State Of WASH.
UTIL. AND TRANSP.
COMMISSION

From: [Karls, Don W](#)
To: [Turcott, Mike \(UTC\)](#)
Cc: [Greg Bowlin](#); trkn_gas@hotmail.com
Subject: RE: industry track agreement
Date: Friday, November 20, 2020 5:54:02 AM
Attachments: [image001.png](#)
[Pages from NDTKSTD Aug 2018.pdf](#)

VanderYacht Propane has petitioned for an exemption of the side clearance requirements for its new propane facility in Mount Vernon. The UTC requires a minimum side clearance of 8'6" from the centerline of track to the nearest structure. The VanderYacht facility has piping and other utilities attached to Unistrut which is 8'0" from the centerline of track. UTC staff will recommend the Commission grant an exemption to its rules in this scenario which will allow BNSF to serve the

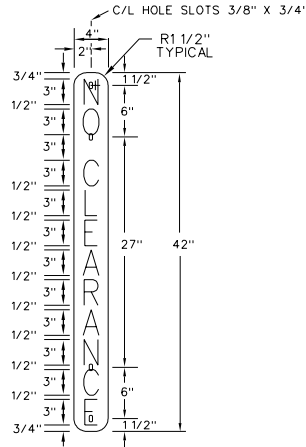
BNSF acknowledges the UTC exemption as highlighted in yellow below and does not take exception to serving this location under UTC exemption terms and where signage complies with BNSF standard (see attached).

Once signage is in place on the structure and verified BNSF will issue the necessary general order and provide UTC with a copy, please advise best address to send this.
